Meeting Agenda

Franklin Municipal Planning Commission

Thursday, January 25, 2024

TUCK AWAY PUD SUBDIVISION VESTING EXTENSION REQUEST RESOLUTION 2023-81

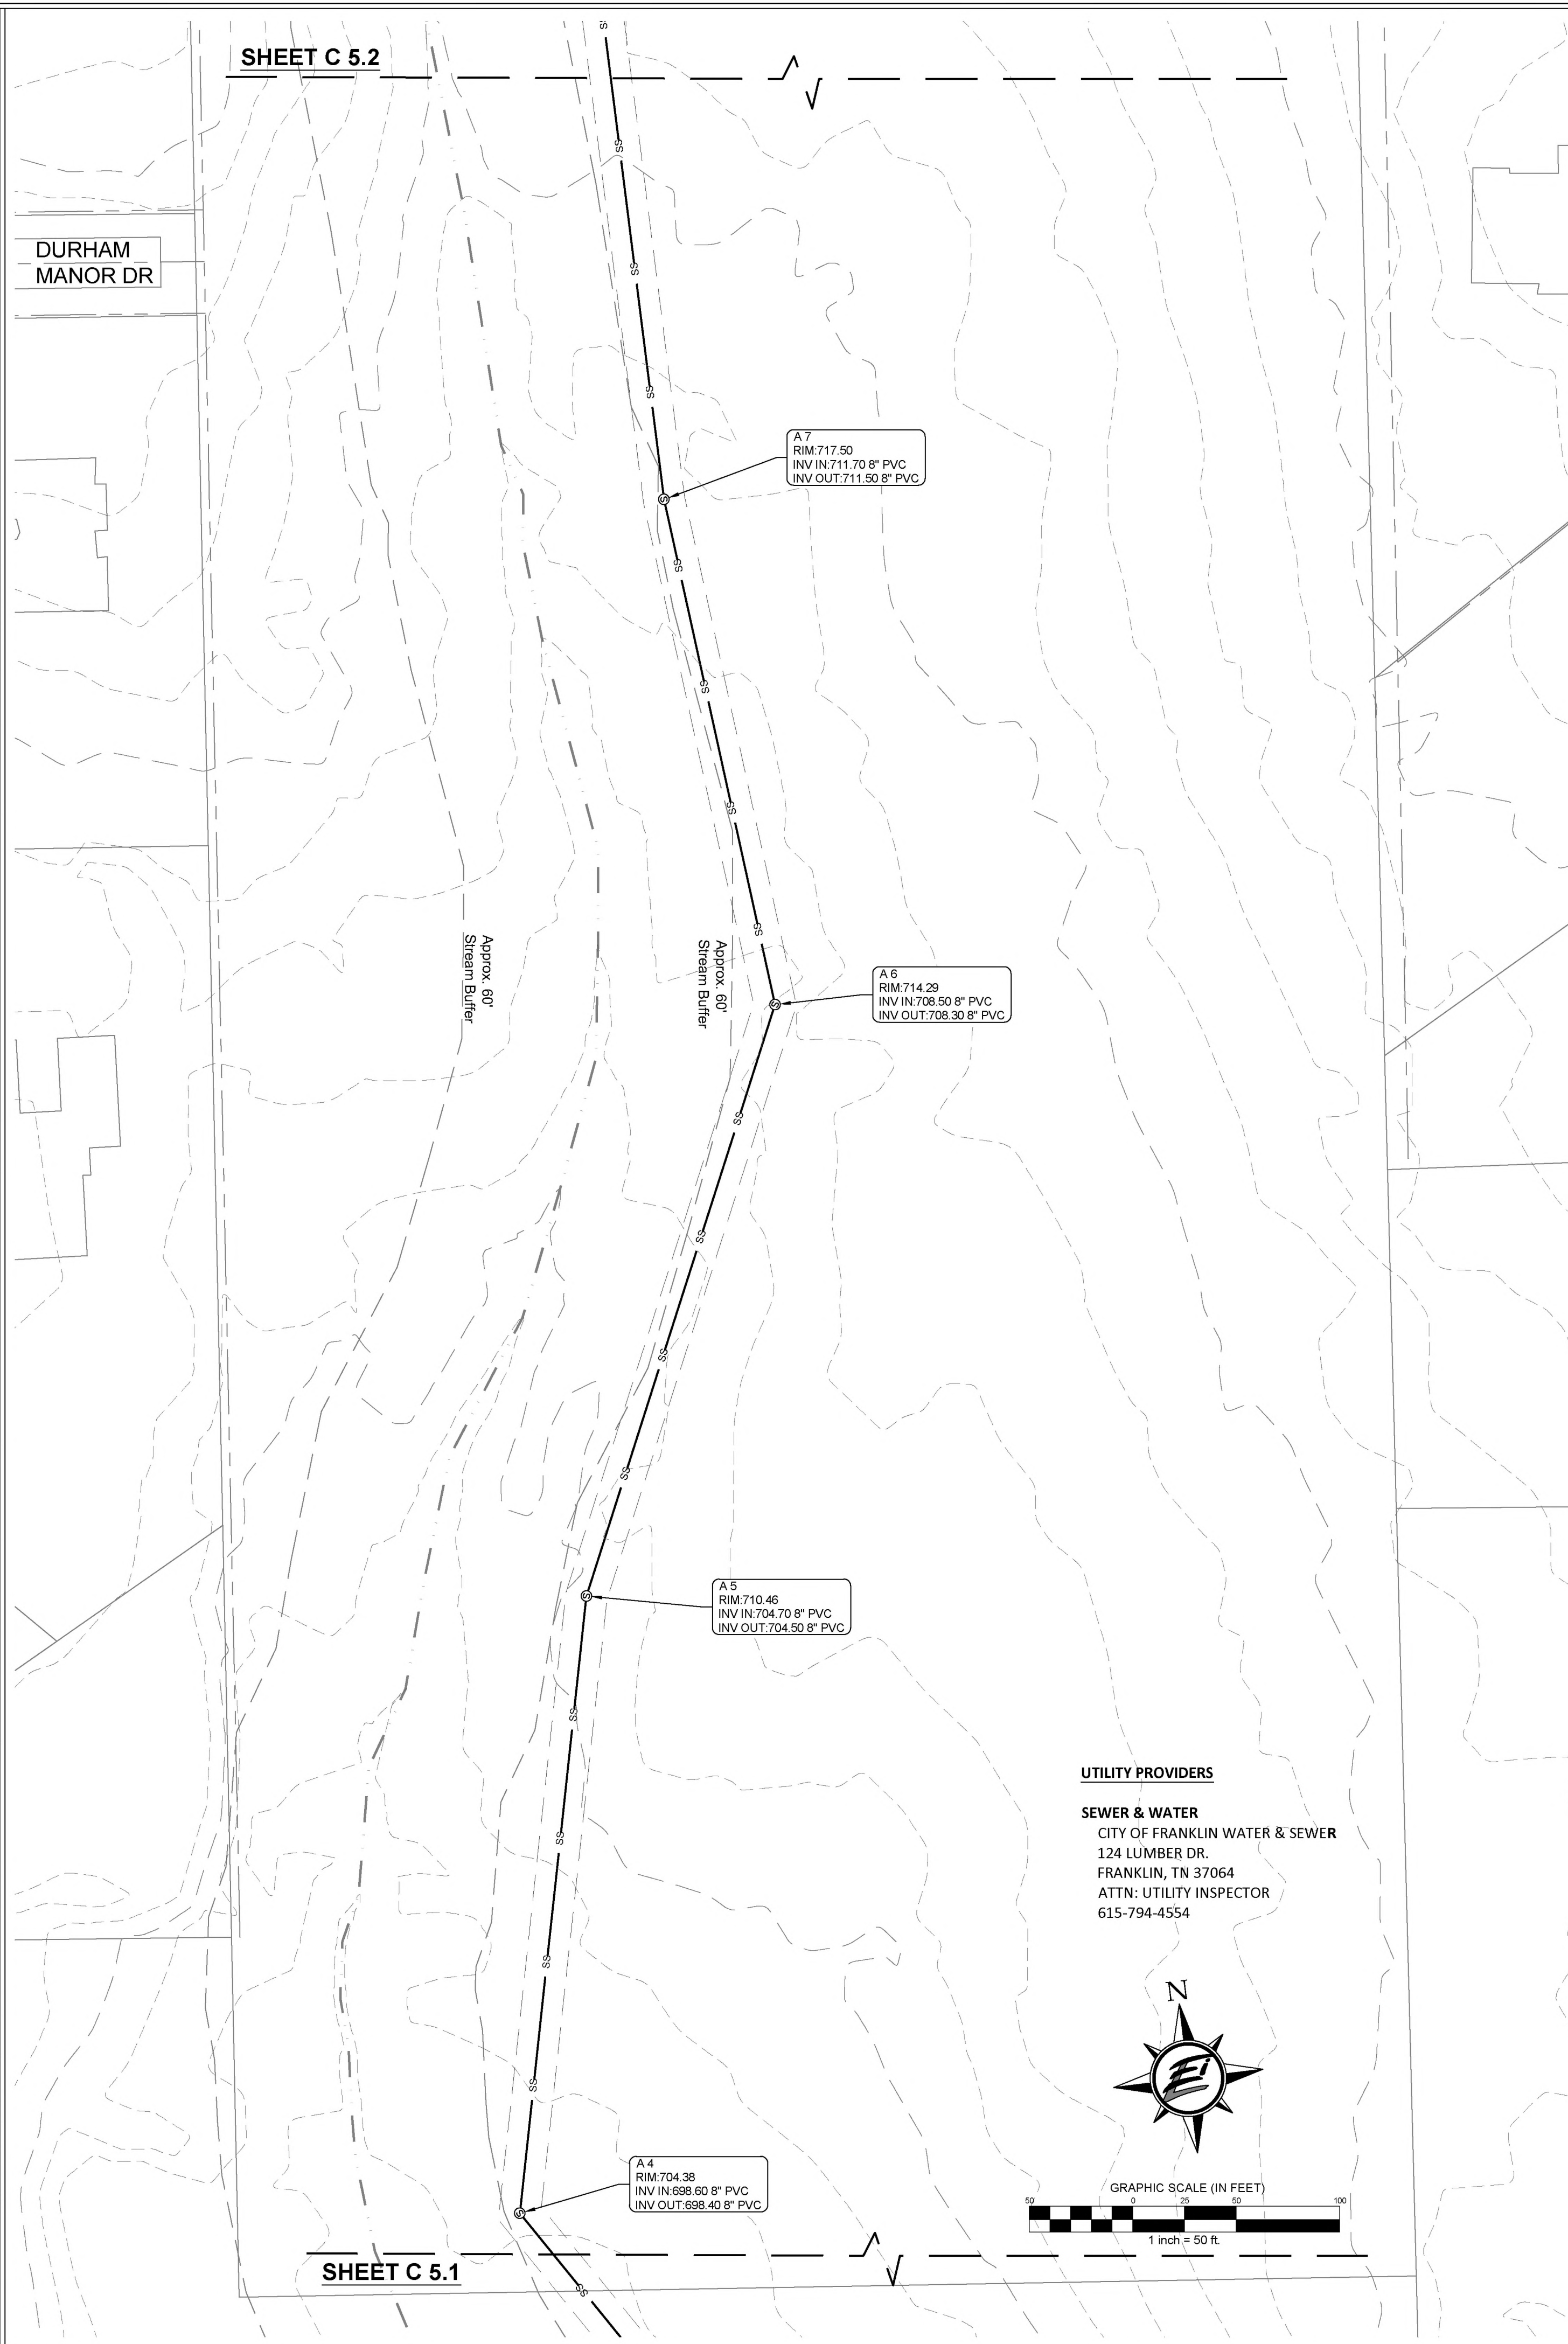
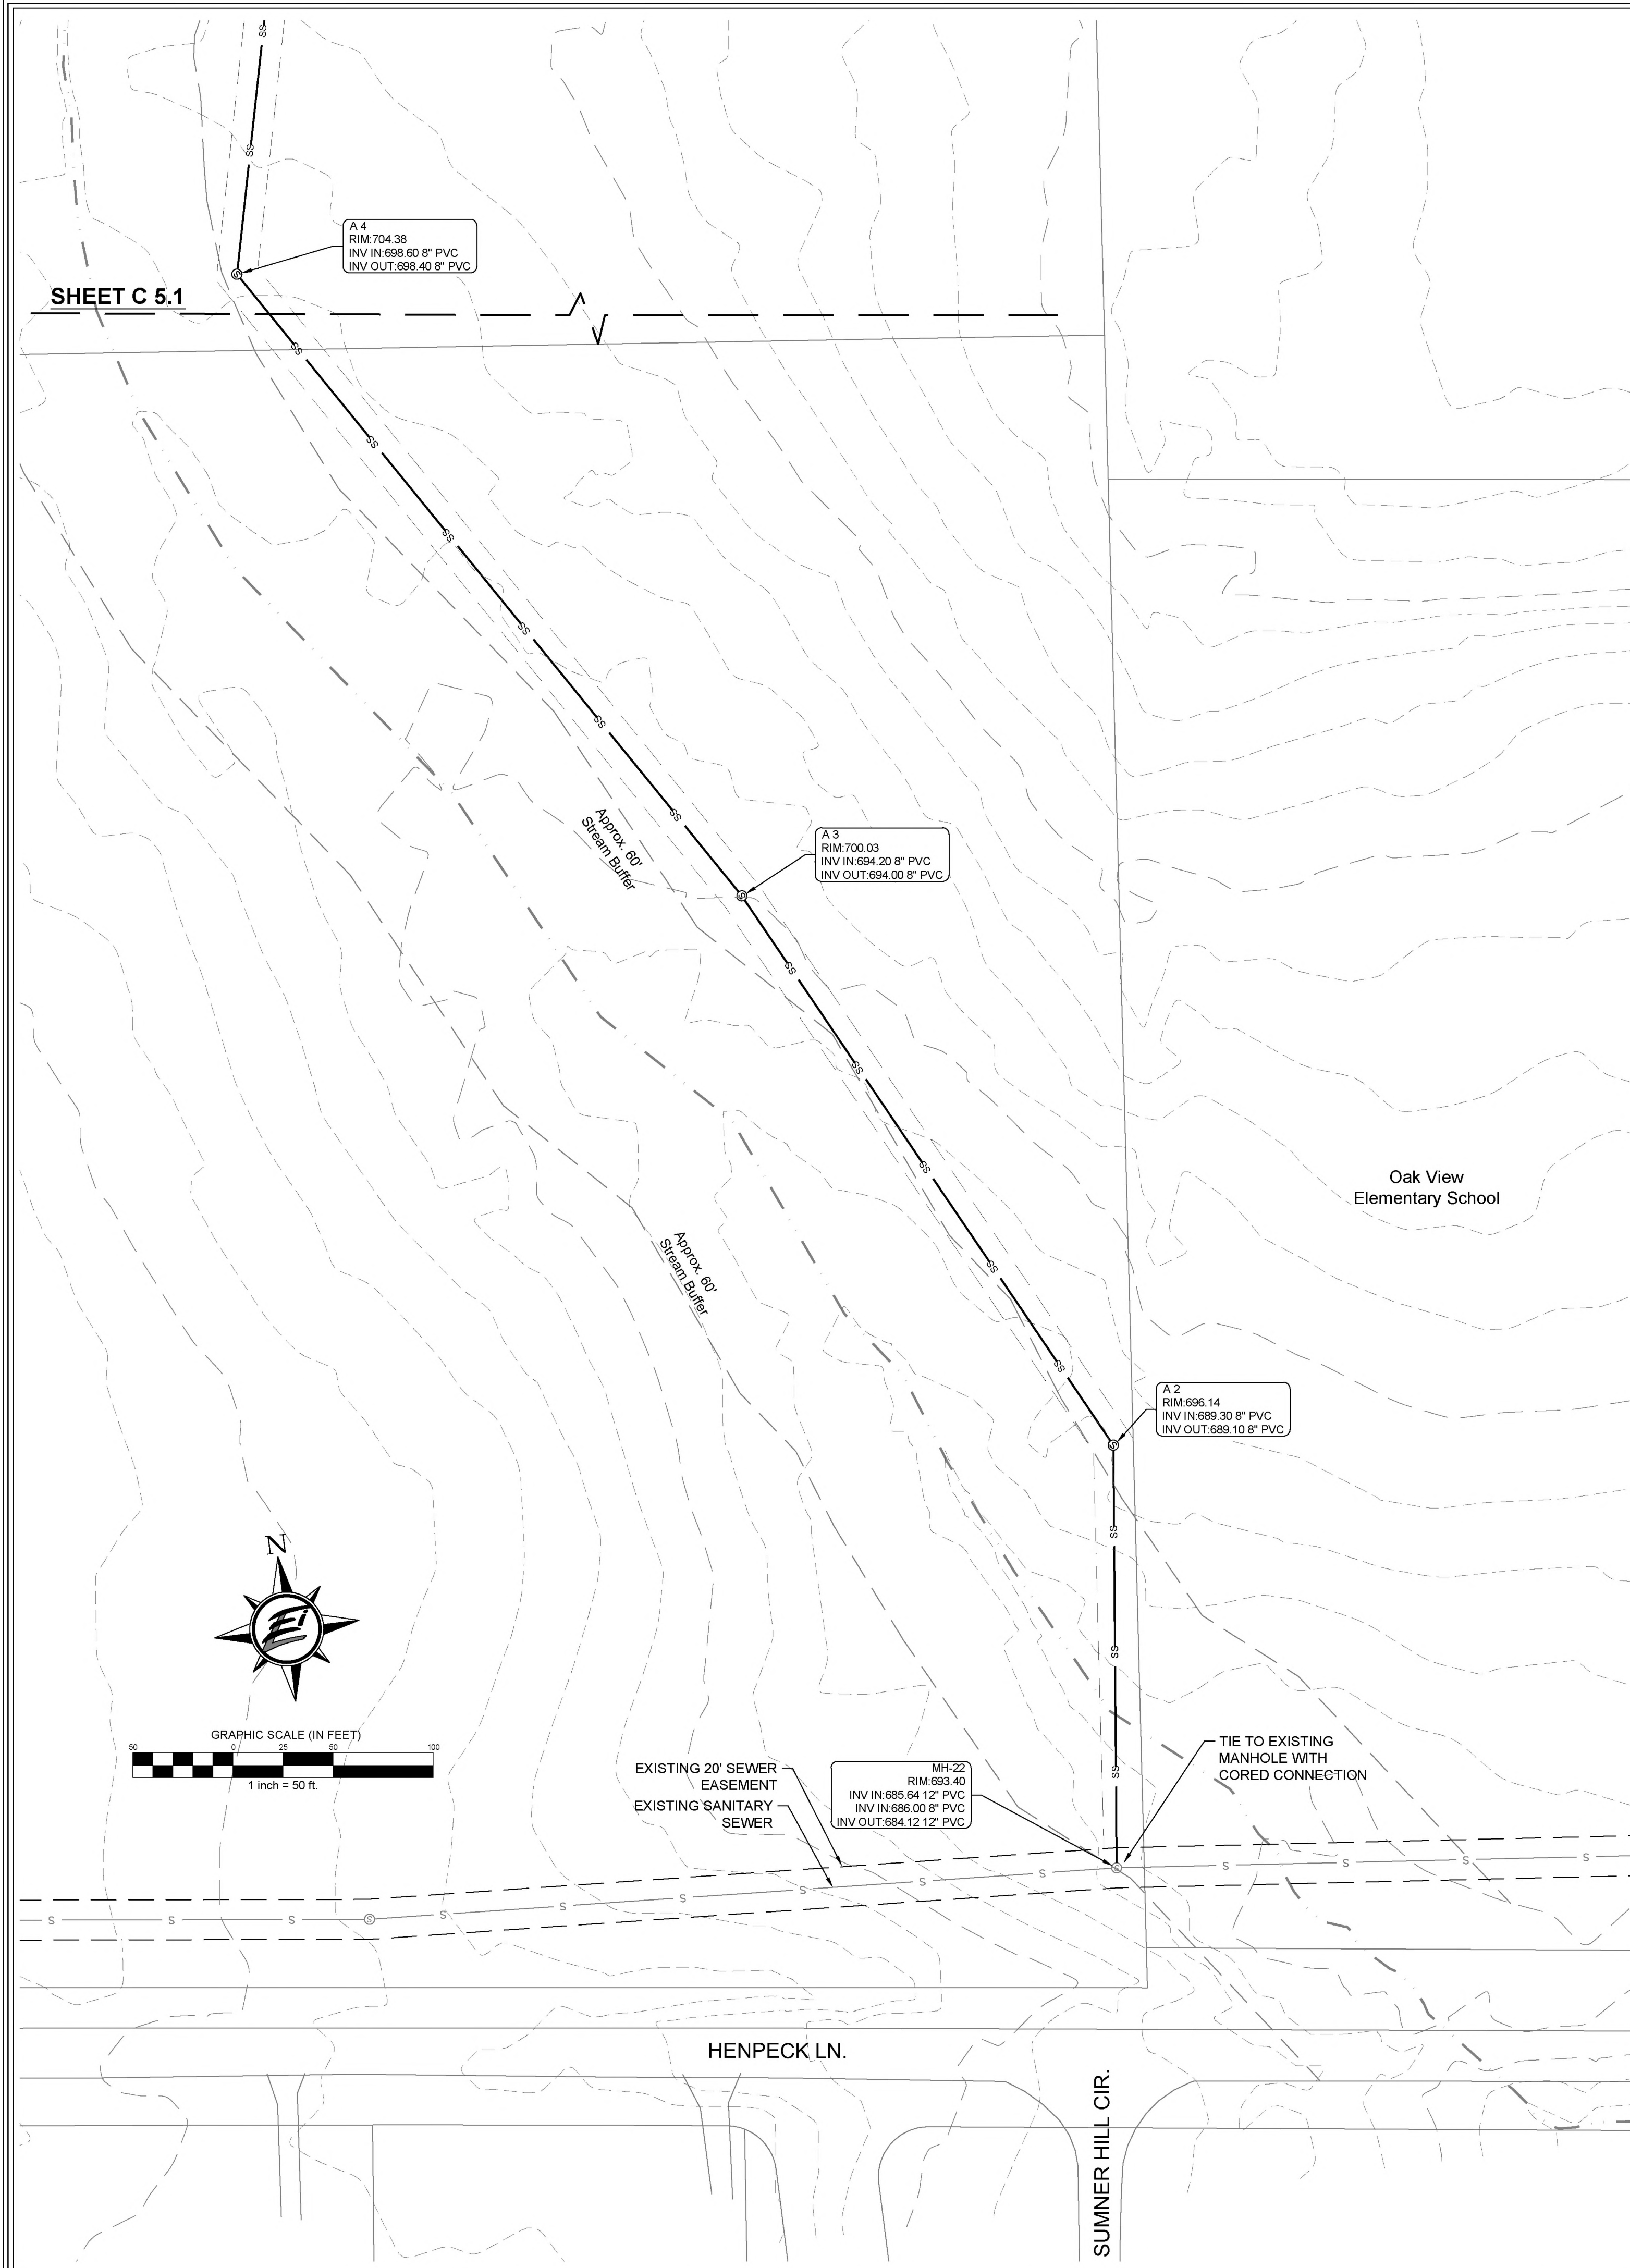
The previous comment, "Identify the existing stormwater outfalls from the property on the Existing Conditions Plan sheet C1.0" has not been addressed. Applicant shall label the existing stormwater outfalls on the Existing Conditions Plan sheet C1.0.
